Application No.	Applicant(s)			
Office Action Summary		10/575,937	OKABE ET AL.			
		Examiner	Art Unit			
		MICHAEL BAND	1795			
	The MAILING DATE of this communication appears on the cover sheet with the correspondence address Period for Reply					
A SHORTENED STATUTORY PERIOD FOR REPLY IS SET TO EXPIRE 3 MONTH(S) OR THIRTY (30) DAYS, WHICHEVER IS LONGER, FROM THE MAILING DATE OF THIS COMMUNICATION. - Extensions of time may be available under the provisions of 37 CFR 1.136(a). In no event, however, may a reply be timely filed after SIX (6) MONTHS from the mailing date of this communication. - If NO period for reply is specified above, the maximum statutory period will apply and will expire SIX (6) MONTHS from the mailing date of this communication. - Failure to reply within the set or extended period for reply will, by statute, cause the application to become ABANDONED (35 U.S.C. § 133). Any reply received by the Office later than three months after the mailing date of this communication, even if timely filed, may reduce any earned patent term adjustment. See 37 CFR 1.704(b).

DETAILED ACTION

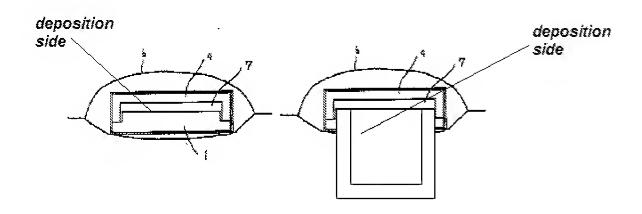
Since the Tanaka et al reference teaches a sputter target [1] having a cover [4] which is rigid, flat, and appears to be transparent to protect the deposition side of said sputter target [1], where a hole [5] traverses through said cover [4], and Ashtiani et al teaches both a planar target comprising a deposition side and a cup-shaped target having an opening to expose a deposition side, the combination of references teach a cup-shaped target having a cover over a deposition side, and thus an opening, where said cover would not extend below said opening. The cropped figure below of fig. 3 from

Tanaka et al serves to further clarify how the cover rests on the rim of the cup-shaped target to protect the deposition side.
